SECTION 00 91 15

ADDENDUM NUMBER 6

- 1.01 DATE: APRIL 6, 2021**
- 1.02 PROJECT: WELCOME CENTER**
- 1.03 PROJECT NUMBER: DCM NO. 2020604**
- 1.04 OWNER: ALABAMA A&M UNIVERSITY**
- 1.05 ARCHITECT: NOLA | VAN PEURSEM ARCHITECTS, PC**

SHEET NUMBER
A-1.3
OF

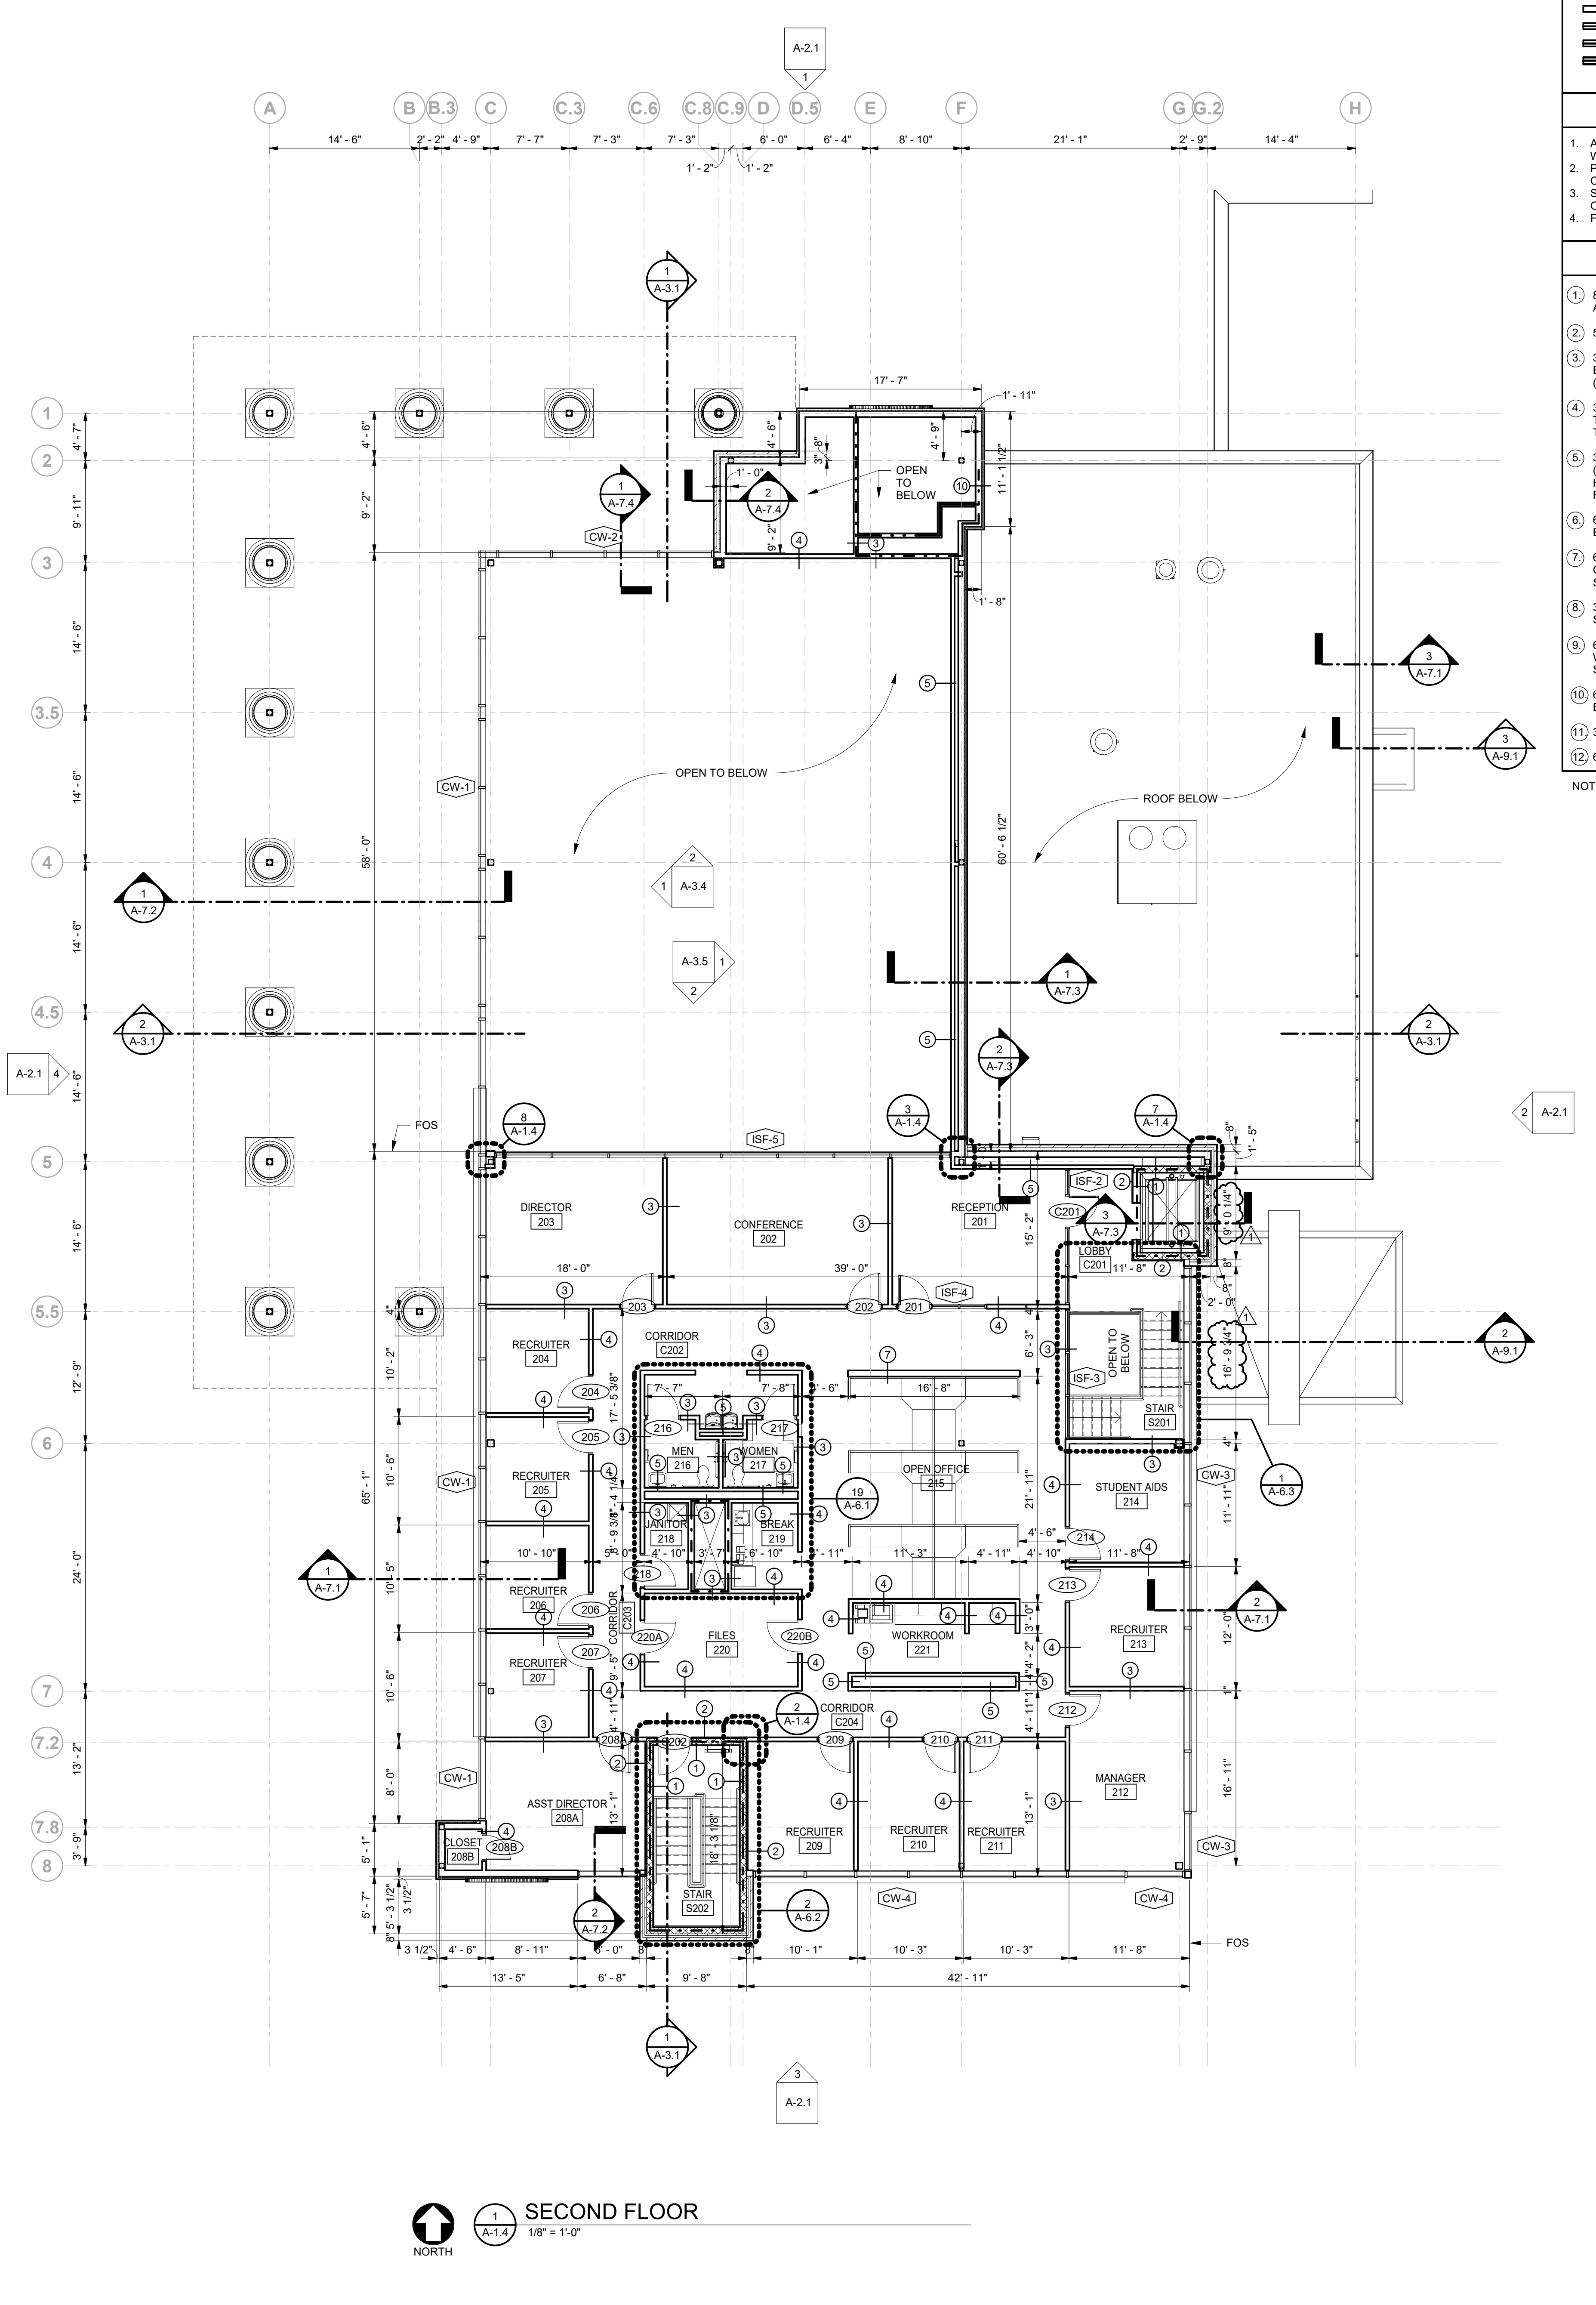
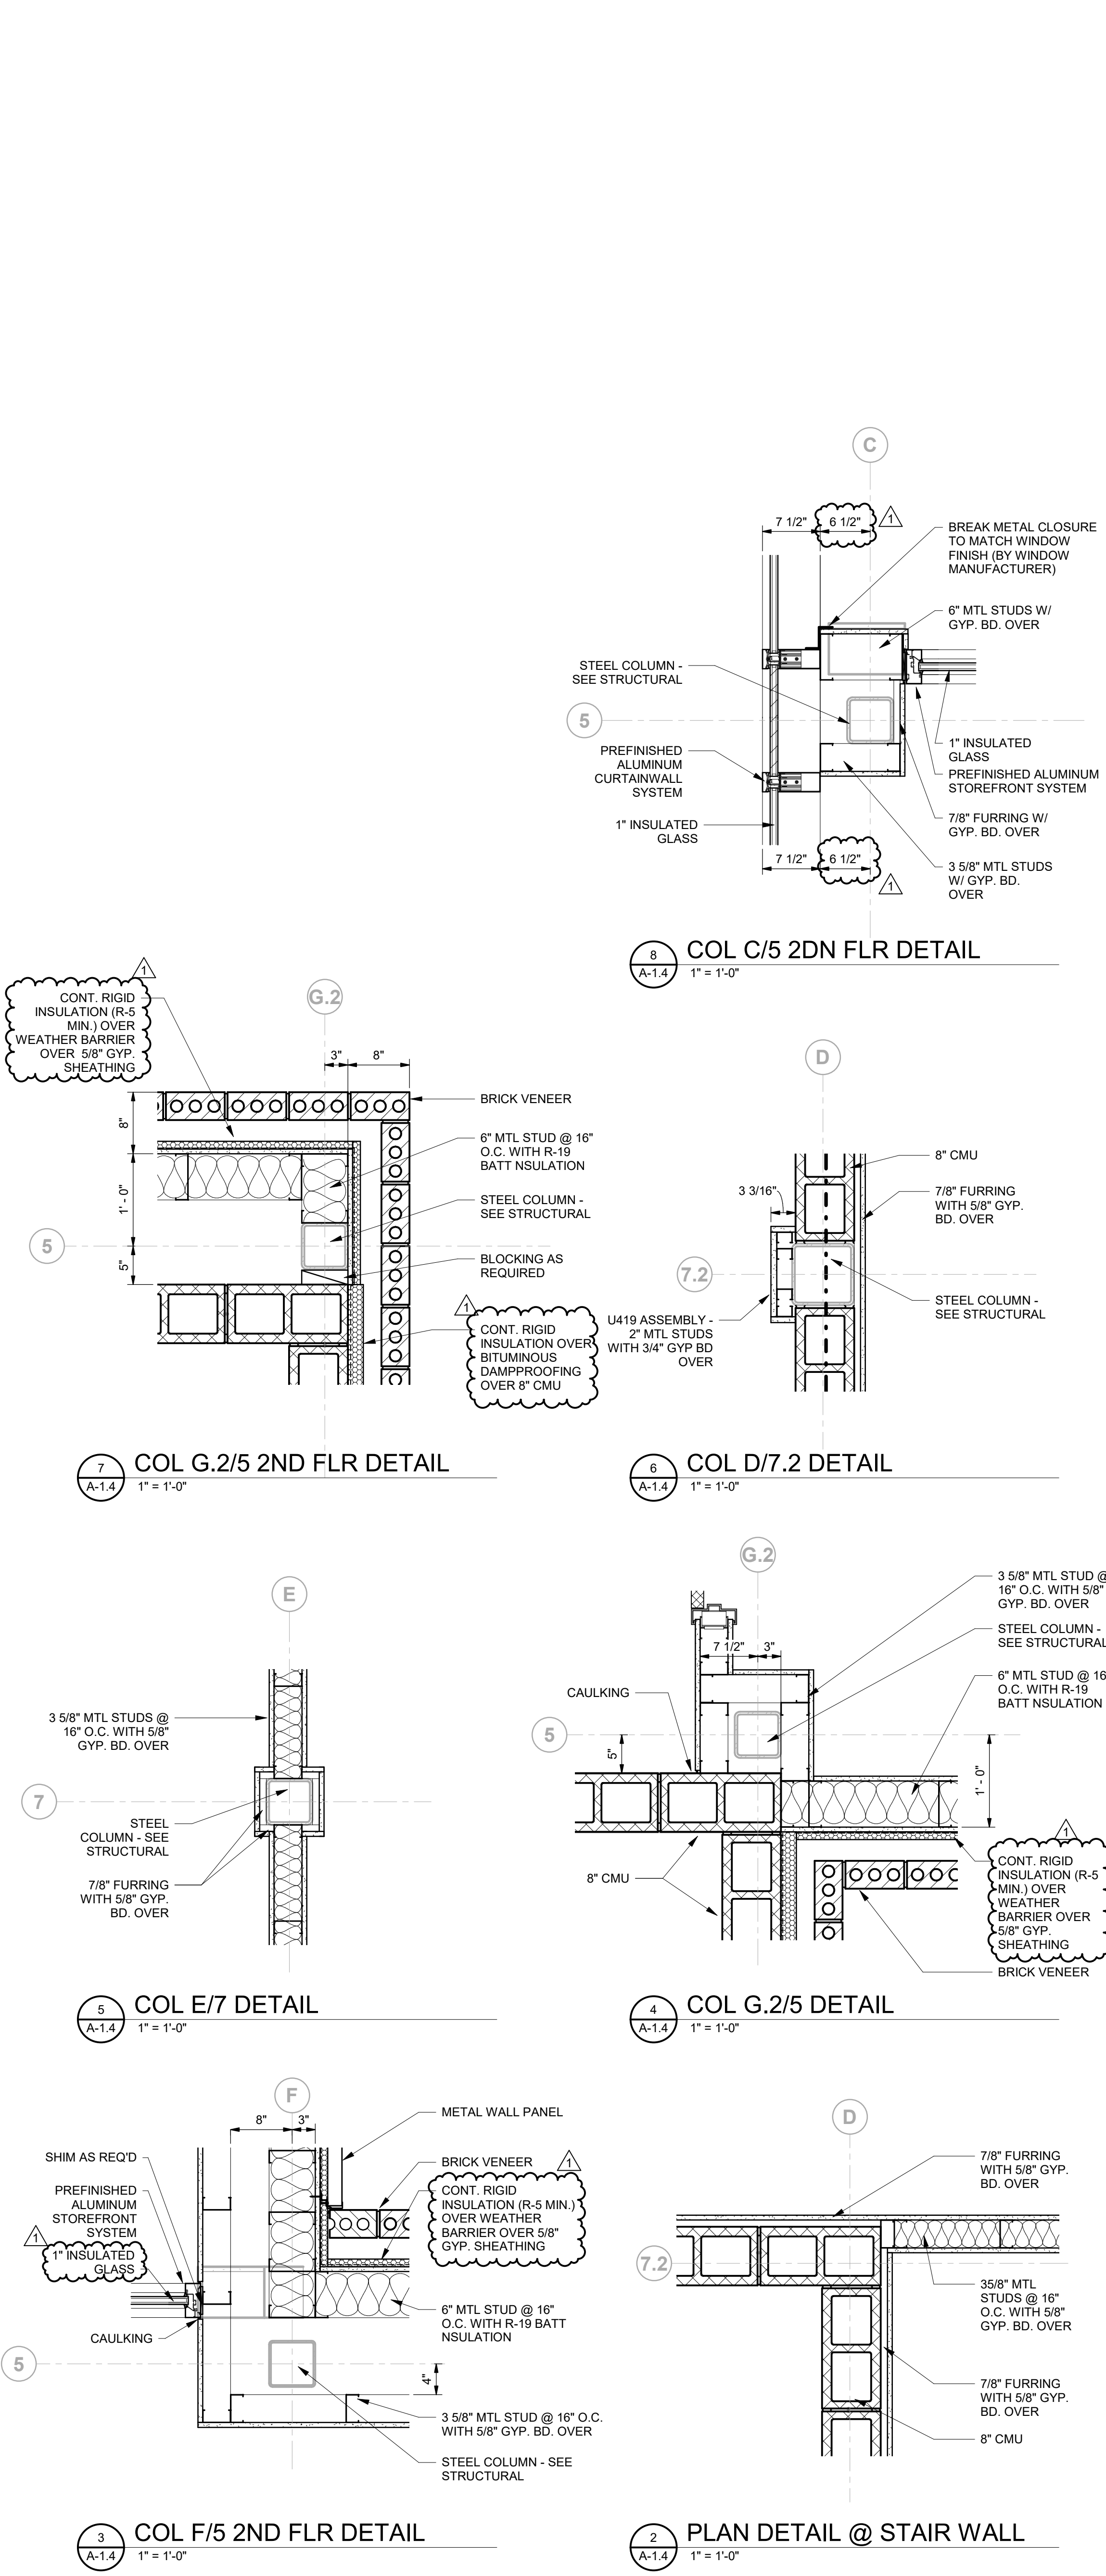
4.07 SHEET A-1.3 – FIRST FLOOR PLAN:

- A. Replace this sheet in its entirety. Revisions include the following:
1. Revise width of elevator shaft

SHEET NUMBER
A-1.4
OF

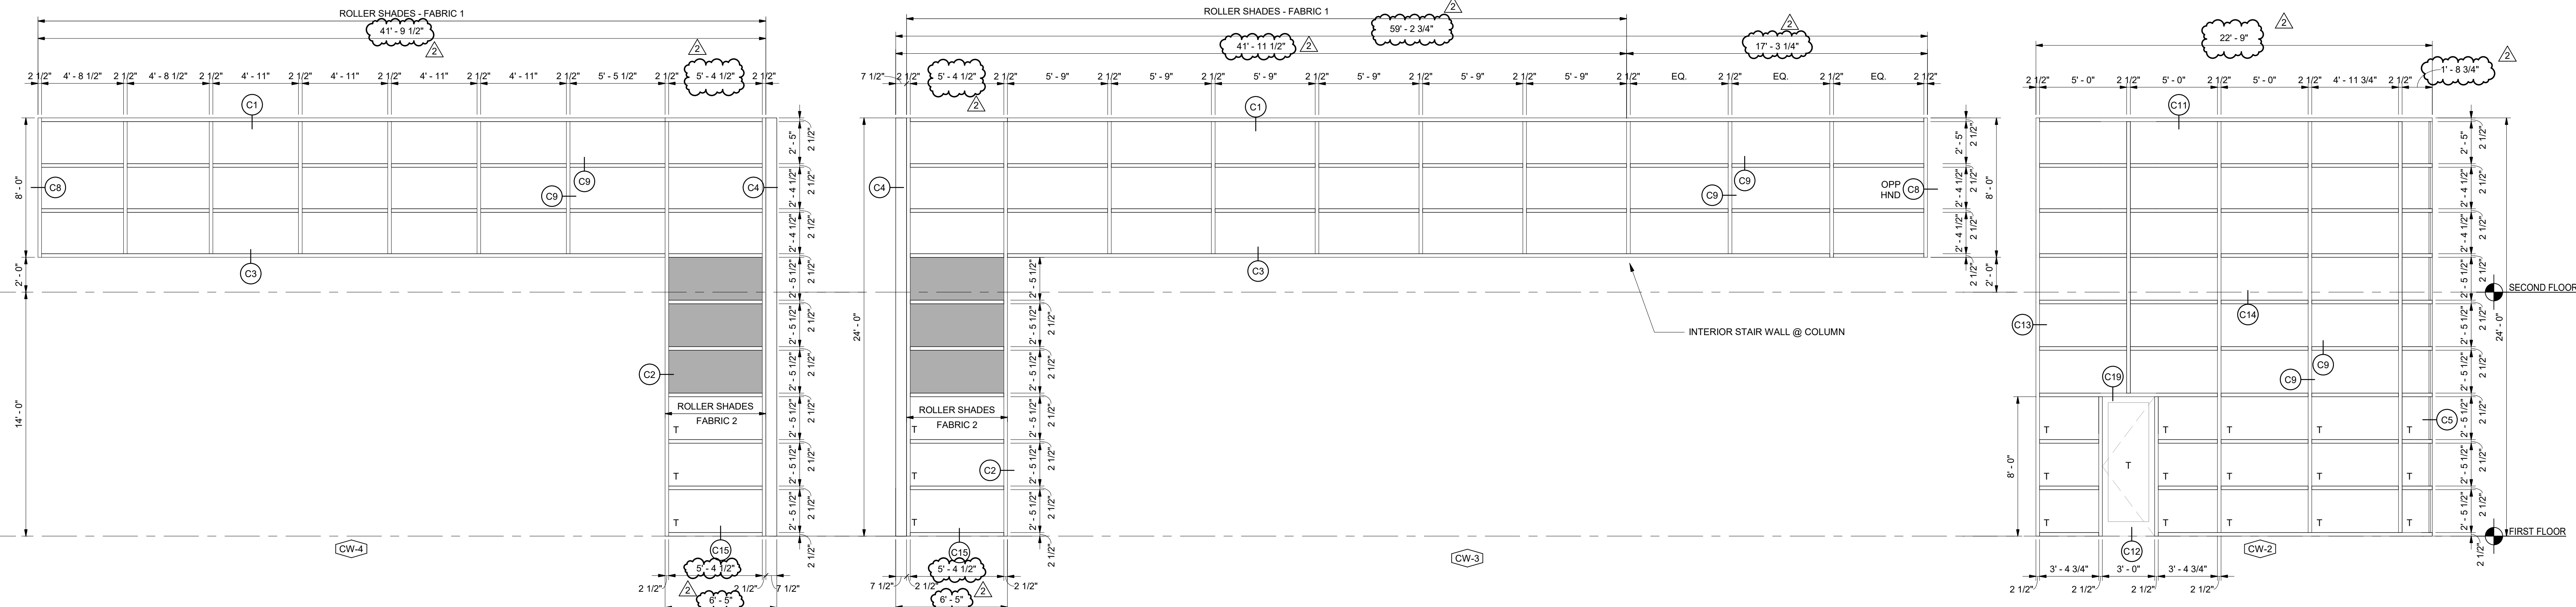
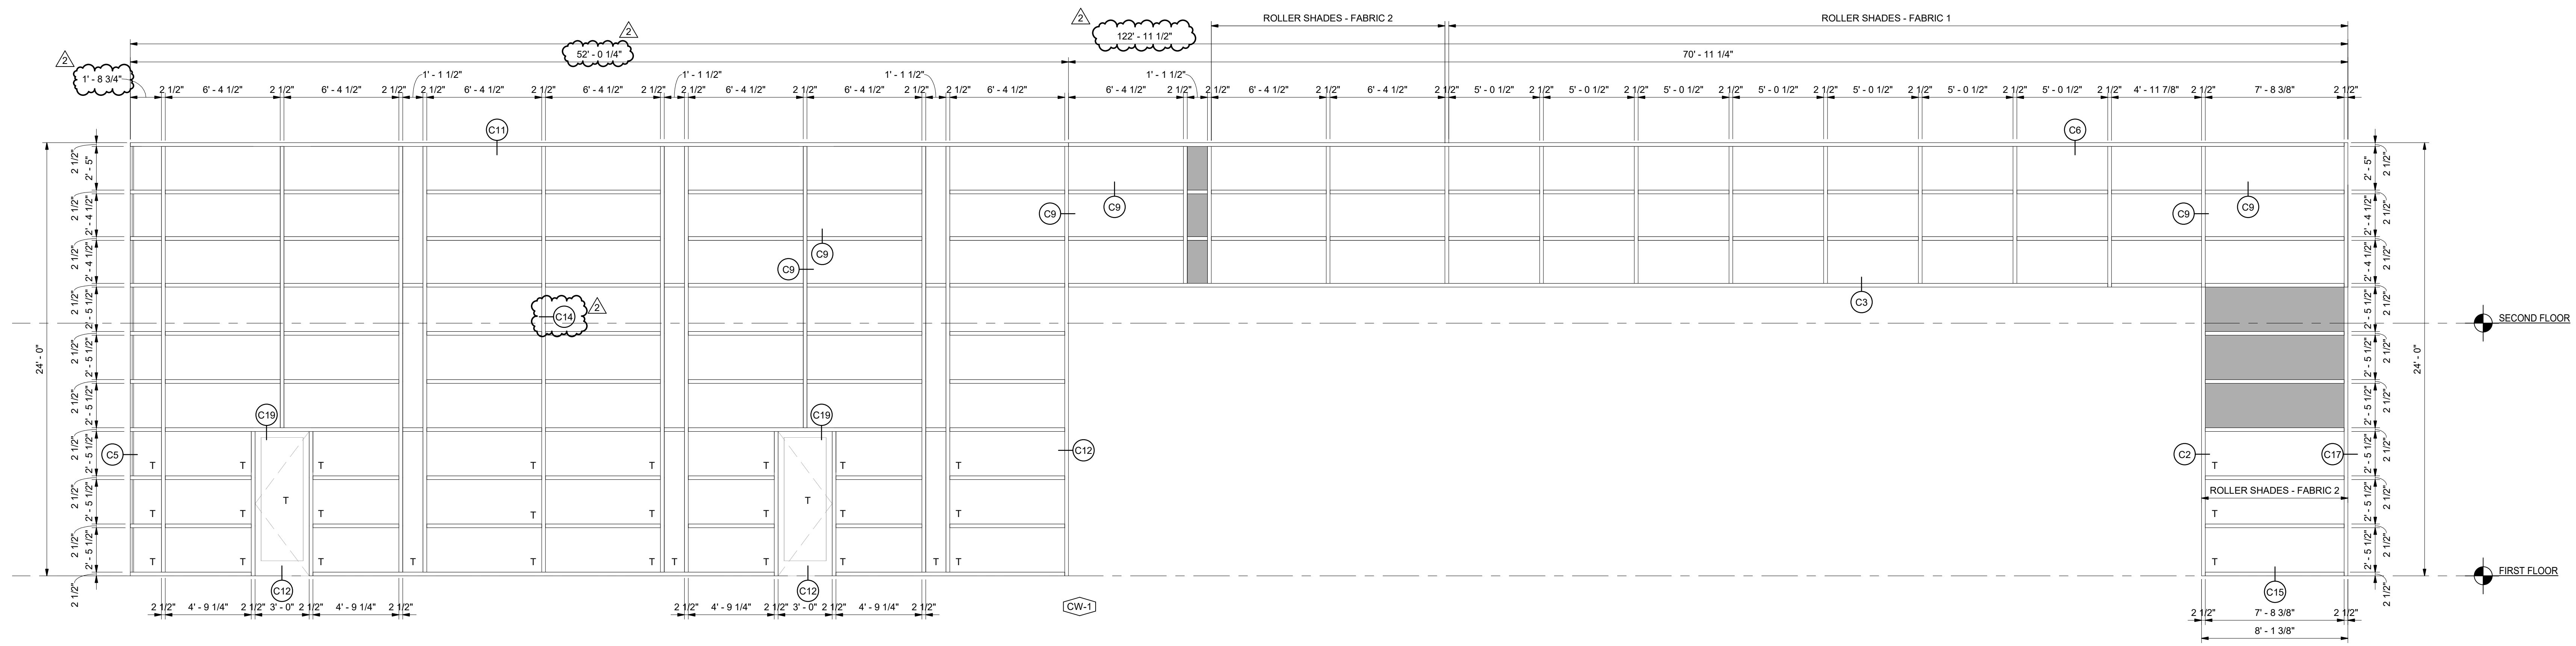
4.08 SHEET A-1.4 – SECOND FLOOR PLAN:

- A. Replace this sheet in its entirety. Revisions include the following:
1. On Column Details 3/ A1.4: Change the note identifying the glass to read “1-inch insulated glass”.
 2. On Column Detail 7/ A-1.4: Change the note which reads “Weather barrier over cont. rigid insulation over 8” CMU” to read “Cont. Rigid Insulation over bituminous dampproofing over 8” CMU”.
 3. On Column Detail 8/ A-1.4: Revise the dimensions which read “8 ½ inches” to read “6 ½ inches”.
 4. Revise width of elevator shaft.
